CERTIFICATION OF THE MINUTES OF THE MEETING OF THE ACRS SUBCOMMITTEE ON RELIABILITY & PROBABILISTIC RISK ASSESSMENT, DECEMBER 14-15, 2006 - ROCKVILLE, MARYLAND

ADVISORY COMMITTEE ON REACTOR SAFEGUARDS MEETING OF THE ACRS SUBCOMMITTEE ON RELIABILITY & PROBABILISTIC RISK ASSESSMENT MEETING MINUTES - DECEMBER 14-15, 2006 ROCKVILLE, MARYLAND

The Subcommittee will review the PRA for General Electric's next generation simplified boiling water reactor, the ESBWR. The Subcommittee will hear presentations by and hold discussions with representatives of the NRC staff and industry regarding this matter. The Subcommittee will gather information, analyze relevant issues and facts, and formulate proposed positions and actions, as appropriate, for deliberation by the full Committee.

BiMAC Detail

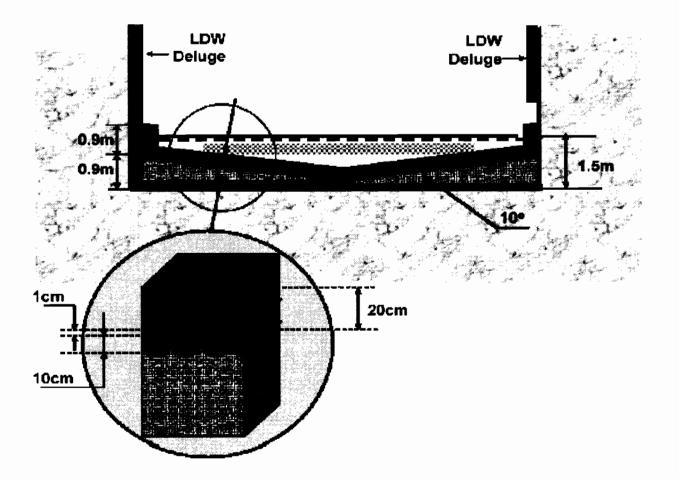
- Dr. Kress asked about the construction material for the walkway over the BiMAC device, and noted that it may become part of the melt. Mr. Wachowiak agreed, and noted that they are considering the materials interactions due to the walkway and other sources such as the control rod drive mechanisms.

Figure 5.1-3. Isolation Condenser System Schematic

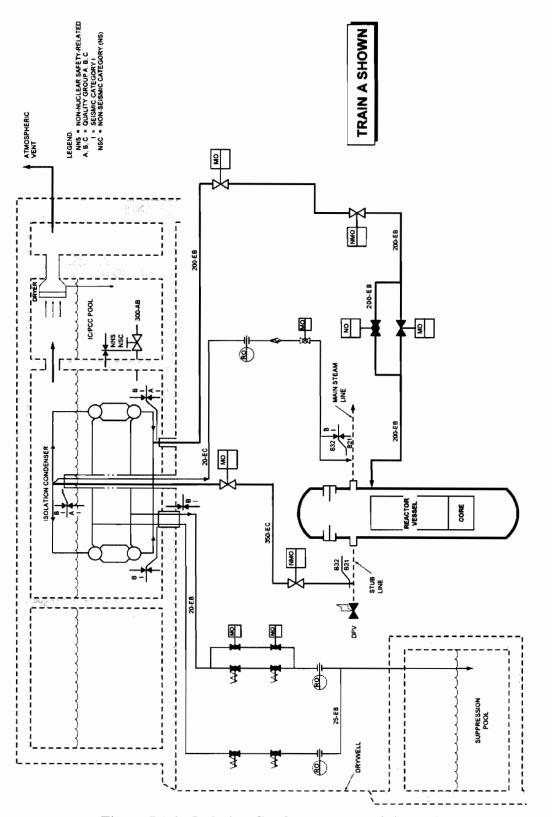
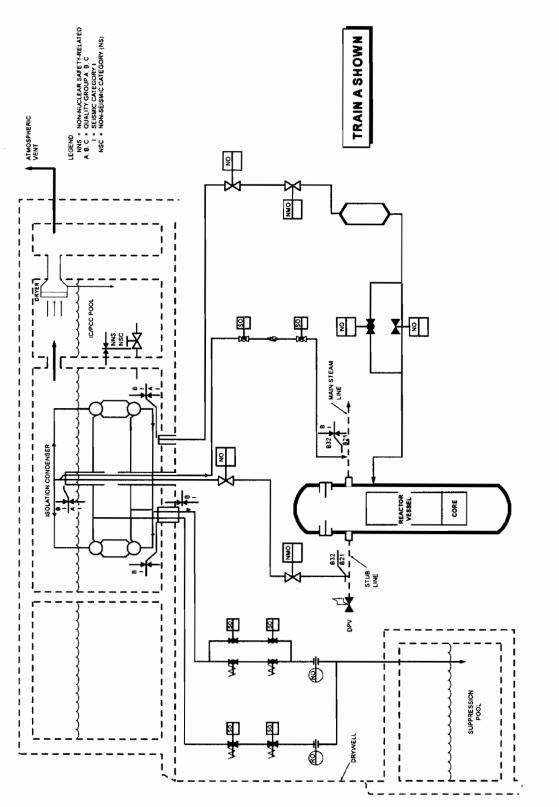
The first detailed discussion of changes by Mr. Wachowiak regarded the changes to the isolation condenser system. By adding nine cubic meters of additional water volume in each isolation condenser, the new design optimizes the emergency core cooling system actuation settings, which reduces the top 90% of cutsets in the Revision 1 PRA. Mr. Wachowiak illustrated the design changes with several stand-alone figures describing the details of the system.

ICS P&ID Figure 5.1-3 Rev 1 Figure 5.1-3 Rev 2 LOFW Water Level Figure 15.2-16c Rev 1 Figure 15.2-16c Rev 2 TGEN Event Tree Figure A.3-1 Rev 1 TFDW Event Tree Figure A.3-3 Rev 1

Add Volume to ICS Condensate Return Lines > 9 m³ per IC
